Drainage Statement

Talbot Mill, Manchester

Report Title:	Talbot Mill, Manchester Drainage Statement
Report Reference:	10531/DS/01
Client:	Capital & Centric
Issue Date:	May 2022
Drafted By:	R Hall
Authorised By:	N Garside

- 1.1 WML Consulting have been commissioned by Capital & Centric, to undertake a review of the previously submitted 'Planning Report Drainage Statement' and 'Pre-commencement Report – Below Ground Drainage' under the planning submission 117595/FO/2017.
- 1.2 The documents reviewed were all by Joule Consulting Engineers, which are the 'Drainage Statement' dated September 2017, and the Pre-commencement Report – Below Ground Drainage' dated November 2018 and the updated drainage calculations dated January 2019.
- 1.3 The above documents establish how the designed drainage achieves the requirements set out in the Manchester City Council Planning Conditions (planning ref 117595/FO/2017).

Title
**PRELIMINARY DRAINAGE
LAYOUT**

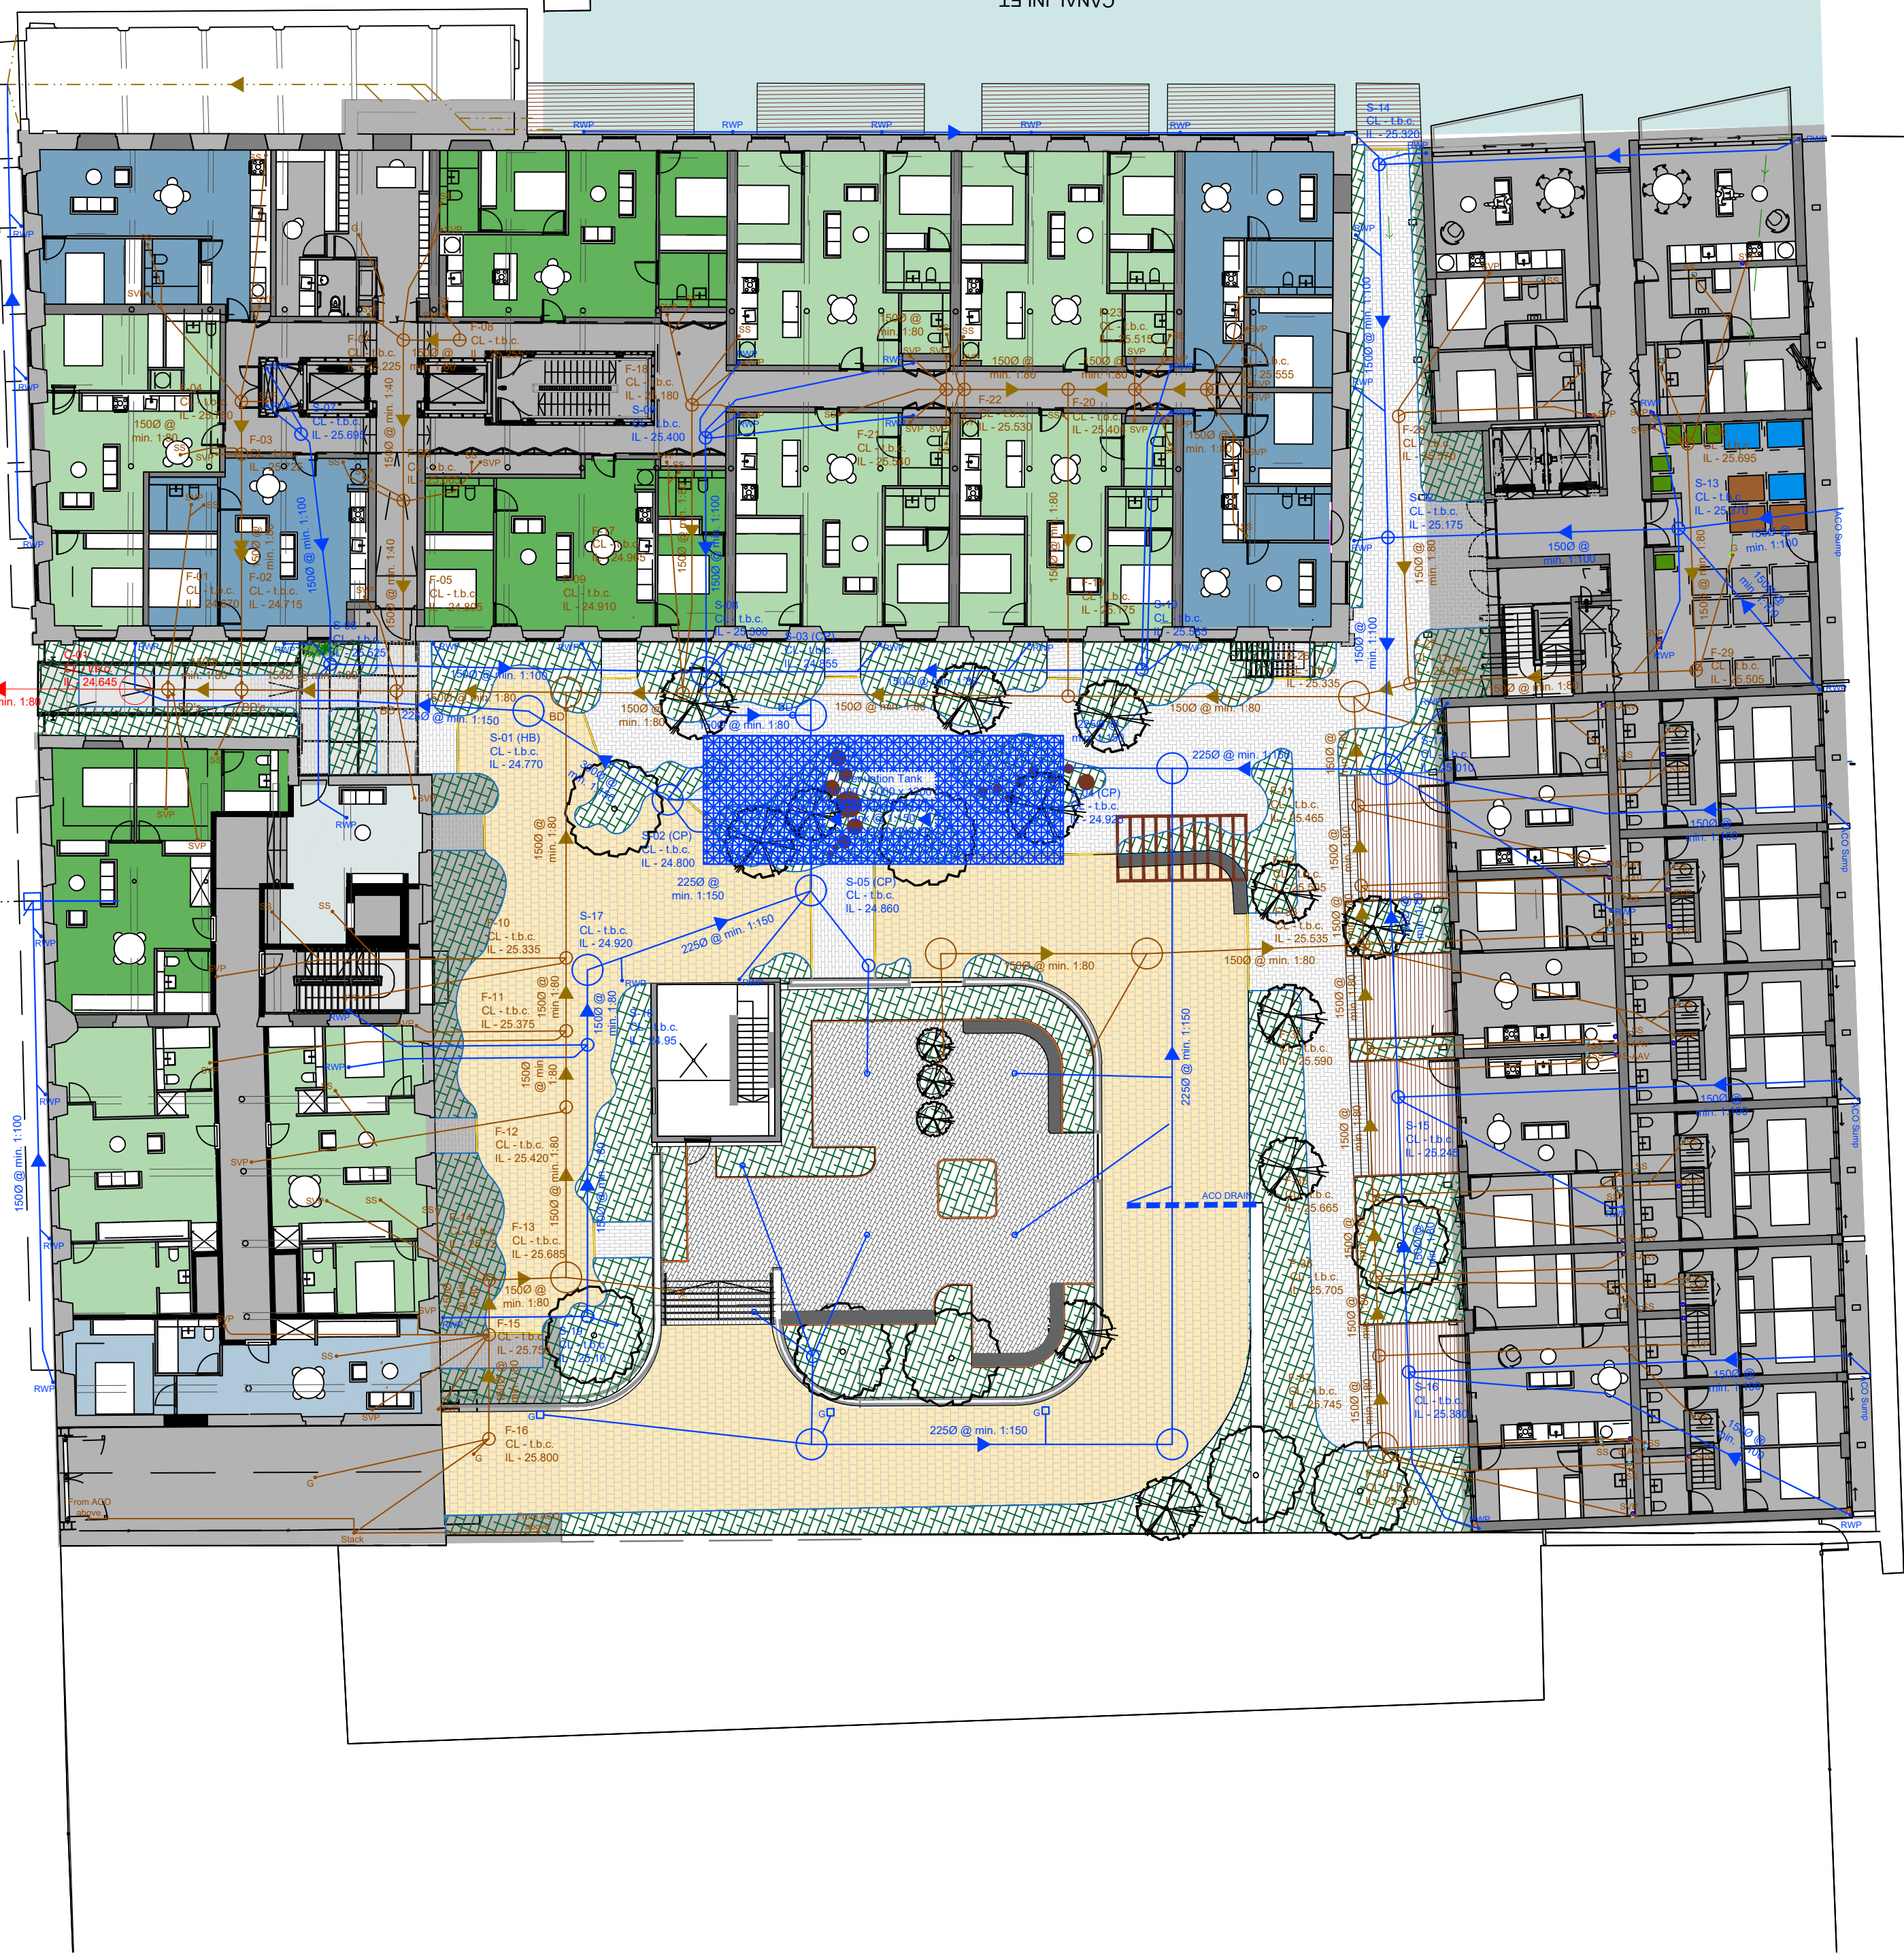
- 6.1 WML Consulting have updated the existing drainage model to incorporate the current site layout proposals. A copy of this is presented in Appendix 02.
